**CITY OF SOUTH MIAMI
OFFICE OF THE CITY MANAGER
INTER-OFFICE MEMORANDUM**

TO: Genaro "Chip" Iglesias, *City Manager*
FROM: Suramy Cabrera, P.E., *Development Services Director*
DATE: December 11, 2025
SUBJECT: A recommendation of the City of South Miami Development Director to approve Minor Modification to the approved development at 6075 Sunset Drive.

A request for Administrative Minor Modification review and approval per City code Section 20-8.7.1 of the approved Special Exception plan for "The Edge at Sunset" at 6075 SW 72nd Street.

THE EDGE AT SUNSET

DRAWN	CONTRACT DATE 02/02/2022
SCALE	AS SHOWN
JOB NO.	2114.PRJ
SHEET TITLE: LEVEL 1 BUILDING PLAN	
SHEET NUMBER: A-2.1-ALT

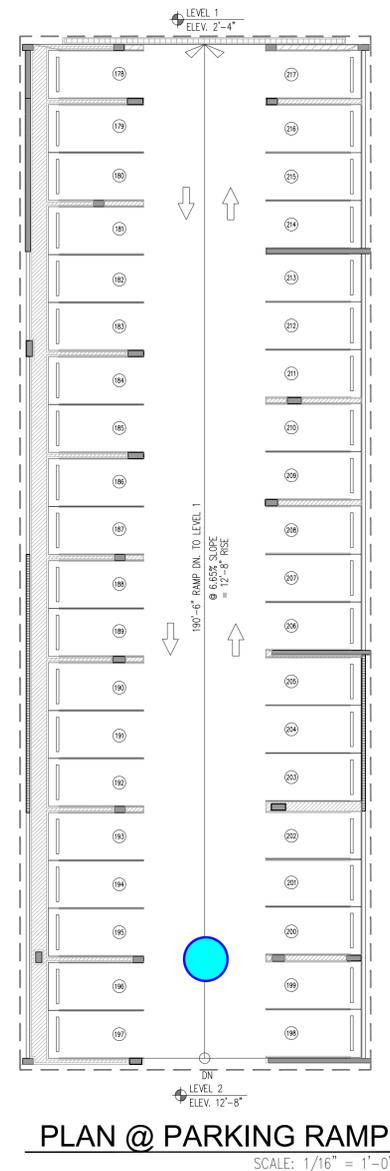
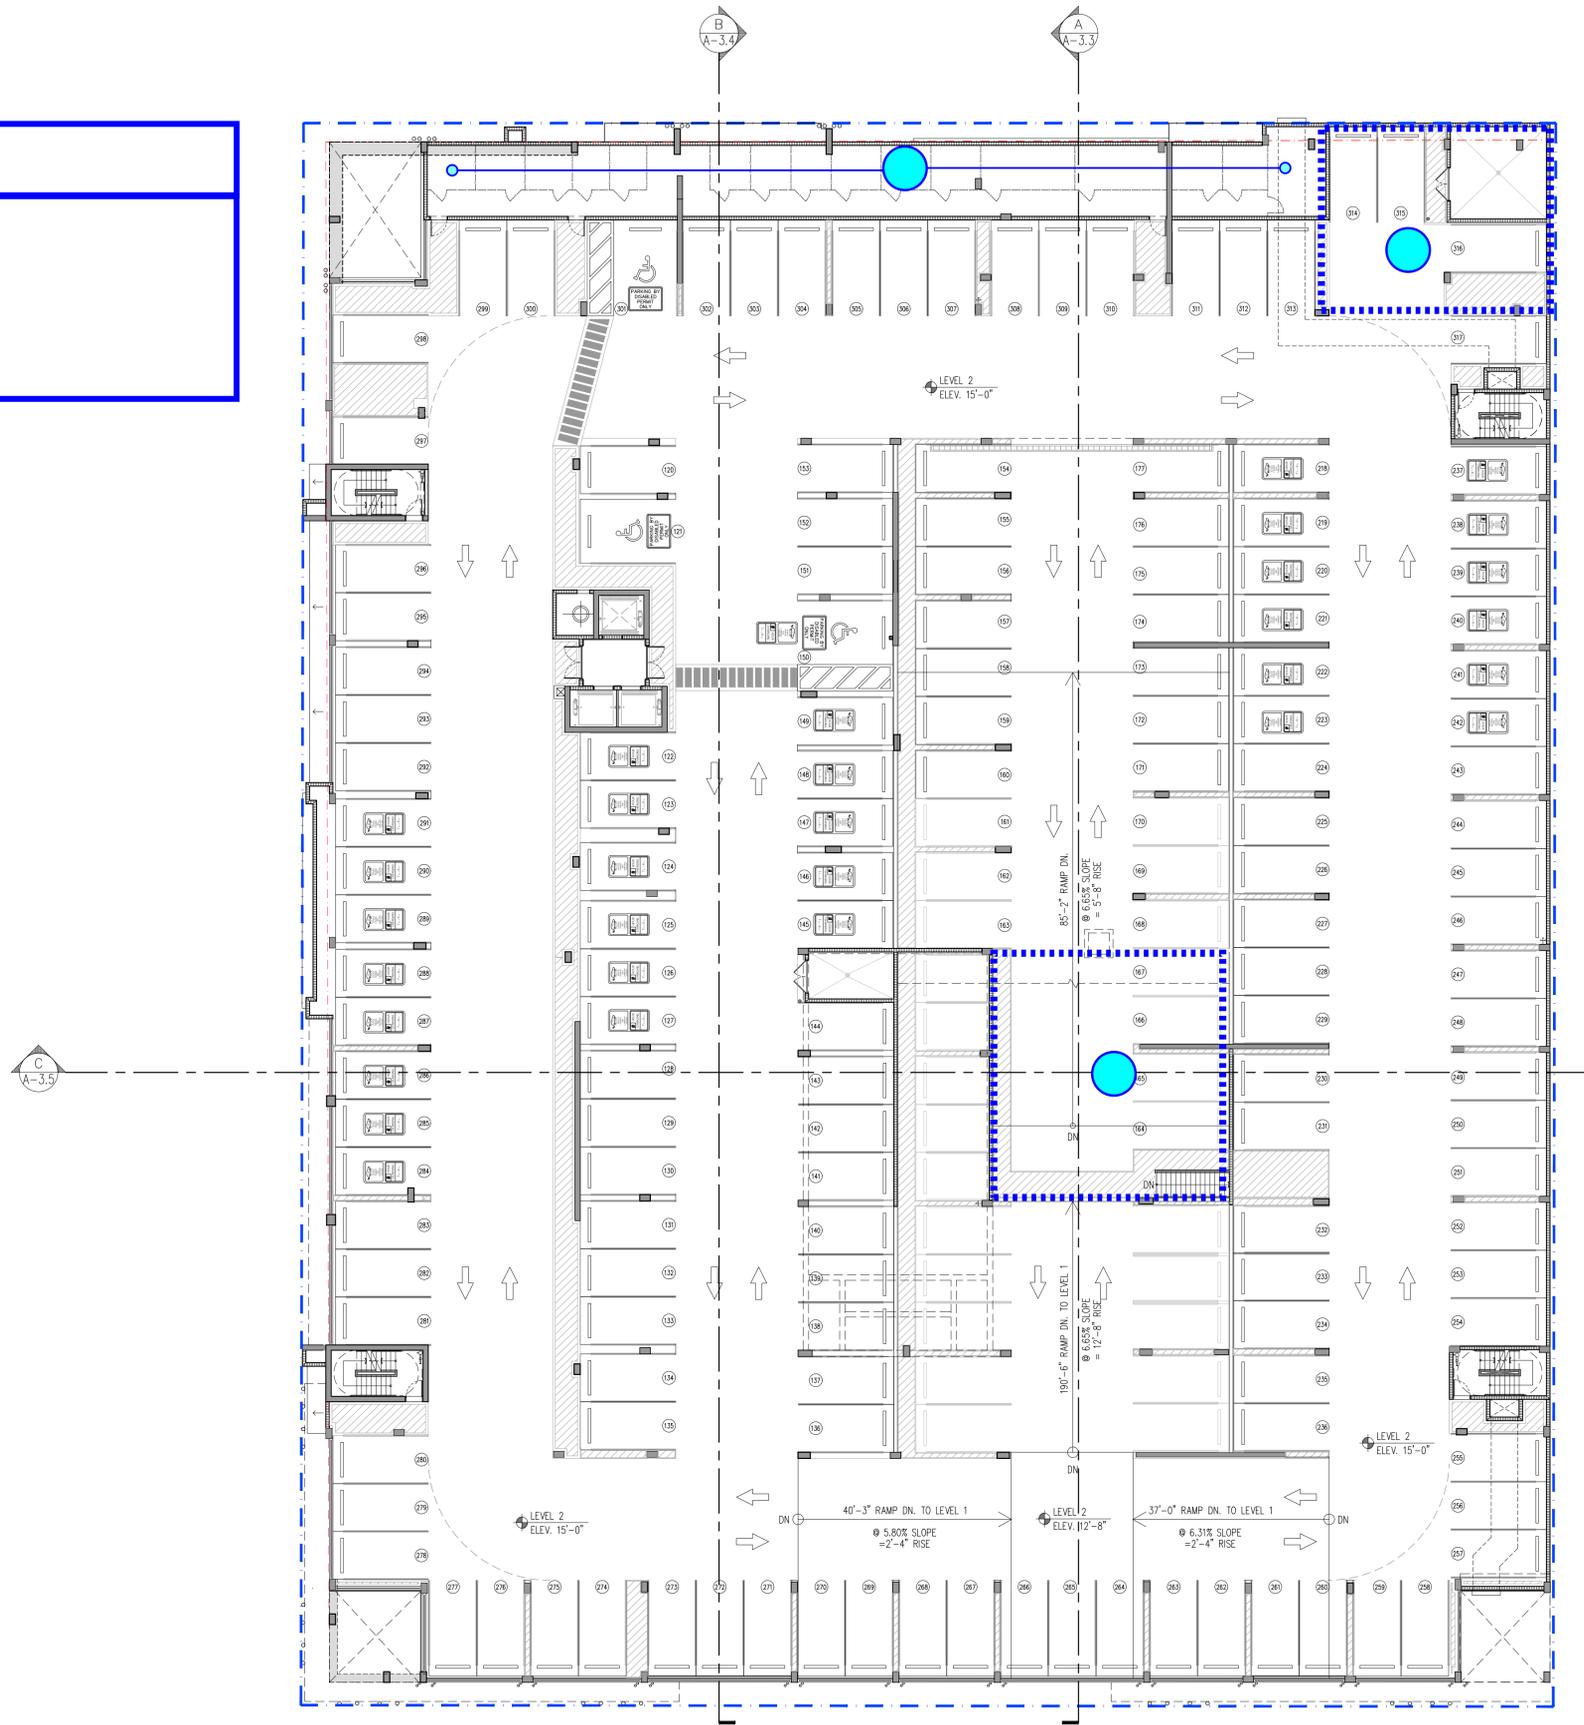
- ### NARRATIVE OF REVISIONS
- 1 ADD 200 SF OF OUTDOOR OPEN SPACE.
 - 2 ADD PLANTER BEDS ALONG SW 61ST AVE.
 - 3 ADD LANDSCAPE & TREES IN FRONT OF MAIN LEASING ENTRANCE ON SW 61ST AVE.
 - 4 ADD 1,500 SF OF ADDITIONAL RETAIL SPACE.
 - 5 ALIGN GARAGE VEHICULAR ENTRANCE WITH THE RAMP DRIVE
 - 6 INCREASE FPL VAULT SIZE PER FPL REQUIREMENTS
 - 7 ADDED OFFICES TO LEASING CENTER
 - 8 RELOCATED AND INCREASED MAIL ROOM
 - 9 ADDED PARKING SPACES
 - 10 ADDED MOVE-IN/STAGING ROOM
 - 11 INCREASE TRASH ROOM SIZE
 - 12 INCREASE LOBBY SIZE
 - 13 RELOCATE ELECTRICAL, PUMP, GENERATOR AND LOADING DOCK

DRAWN	CONTRACT DATE 02/02/2022
SCALE AS SHOWN	JOB NO. 2114.PRJ
SHEET TITLE: BUILDING ELEVATIONS	
SHEET NUMBER: A-3.1-ALT

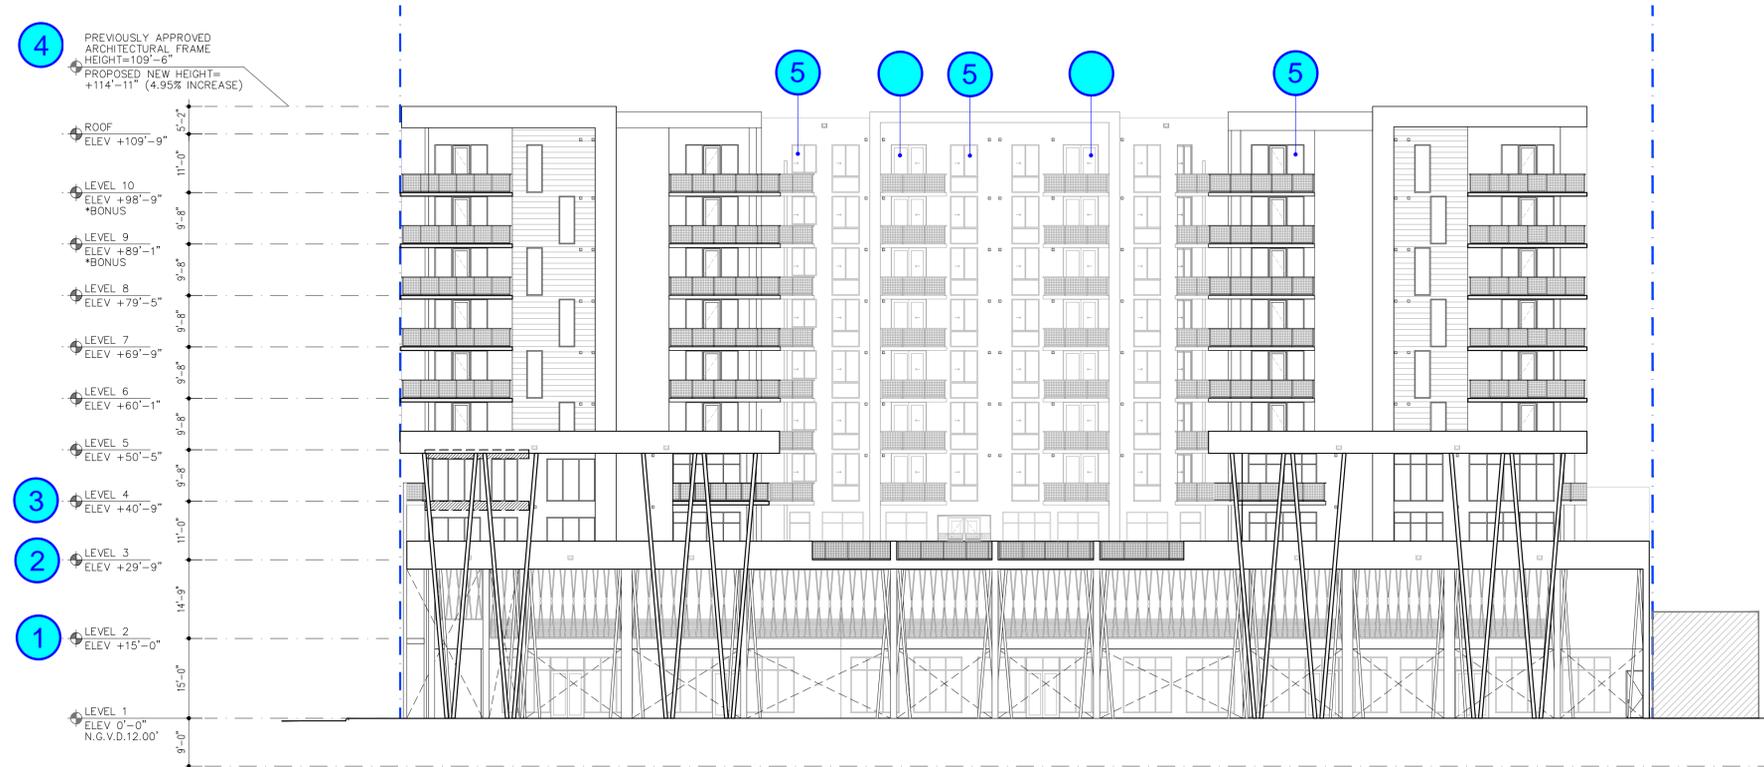
NARRATIVE OF REVISIONS	
1	INCREASE LEVEL 1 HEIGHT FROM 12'-8" TO 15'-0".
2	INCREASE LEVEL 2 HEIGHT FROM 9'-8" TO 14'-9".
3	INCREASE LEVEL 3 HEIGHT FROM 9'-8" TO 11'-0".
4	
5

DRAWN	CONTRACT DATE 02/02/2022
SCALE AS SHOWN	JOB NO. 2114.PRJ
SHEET TITLE: BUILDING ELEVATIONS	
SHEET NUMBER: A-3.2-ALT

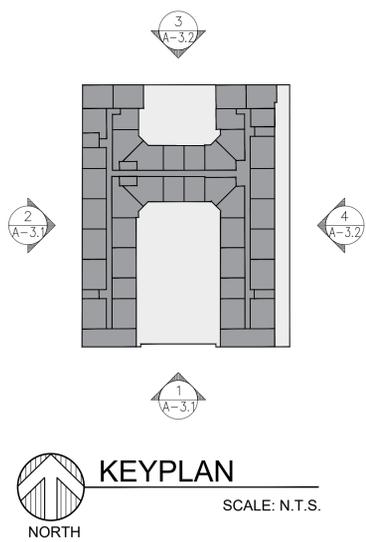
- 1 INCREASE LEVEL 1 HEIGHT FROM 12'-8" TO 15'-0".
- 2 INCREASE LEVEL 2 HEIGHT FROM 9'-8" TO 14'-9".
- 3 INCREASE LEVEL 3 HEIGHT FROM 9'-8" TO 11'-0".
- 4
- 5
